Fire Department Vehicle Access Review

Project: Parkside Apartments & Condos
383-385 Washington Street
Braintree, Massachusetts

Date: October 15, 2019

PLAN TITLE:
EMERGENCY VEHICLE ACCESS SKETCH

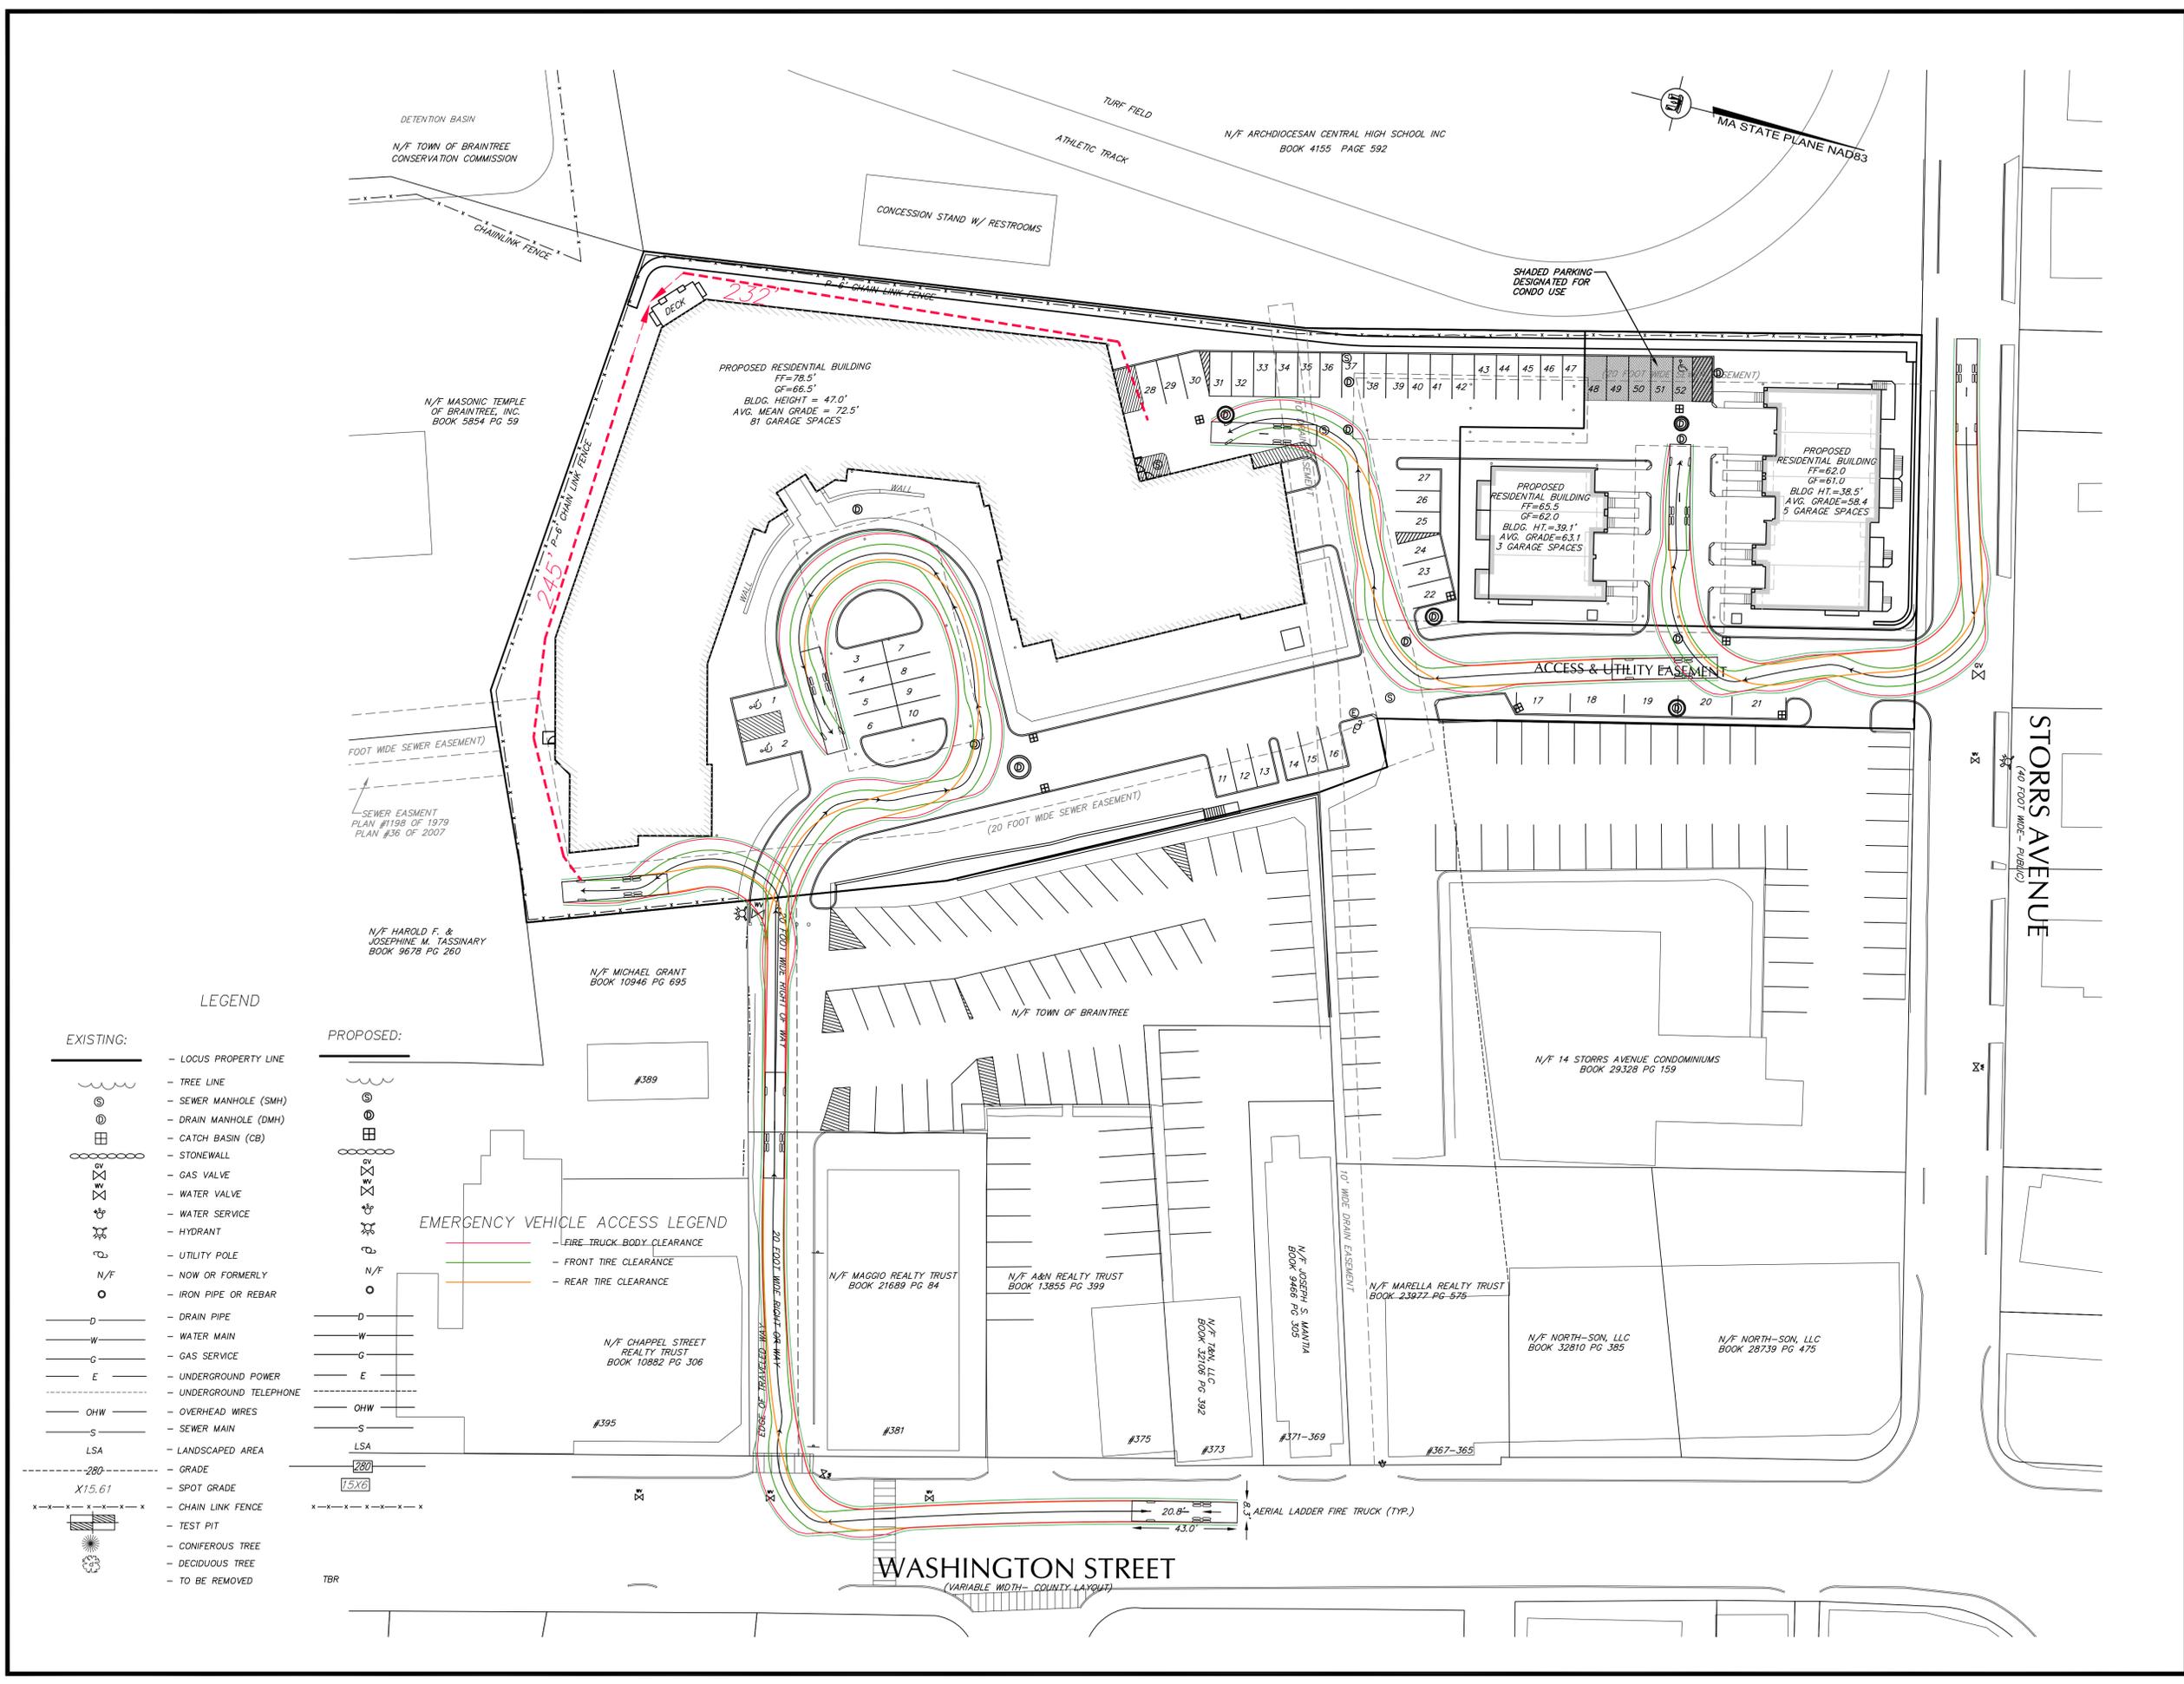
As shown in the Emergency Vehicle Access Sketch, the fire department access roads allow fire department vehicles to be positioned so that all portions of the building perimeter are within 250 feet.

The Emergency Vehicle Access Sketch indicates that the roads will accommodate turning of the fire departments largest vehicle.
